Eng: David Mundie PCB#1070700 <User Ext.#3> <User Ext.#4> <User Ext.#5>		Paul C. Buff Inc. 2725 Bransford Ave. Nashville, TN 37204 <Address #4>	
Sheet Title: RadioRemote One Main		Sheet Title: RadioRemote One Main	
Sheet File Name: RFRremote1X.sch		Sheet File Name: RFRremote1X.sch	
Sheet Creation Date: 02/19/99		Sheet Creation Date: 11/19/1999	
		SHEET 1 OF 5

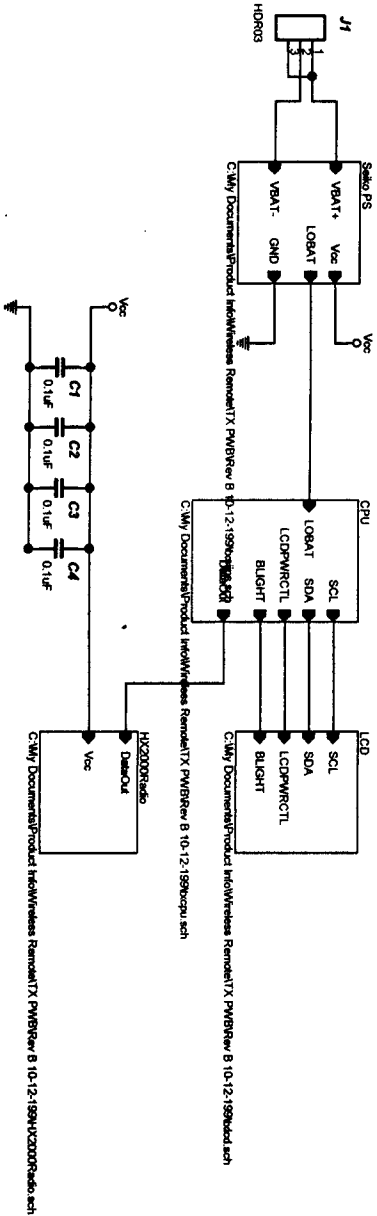
Revision History
Rev A Change R6 on Sheet 4 from 10K to 1K
Rev B Change from pull up to resistor divider on Sheet 4
Rev C Change 10uF caps to 22uF in PS circuits
Rev D Change R5 from 75ohm to 27ohm
Rev E Add LCD Power Control
And Sync Diode Protection
and Add TX Power Shunt Resistor R9
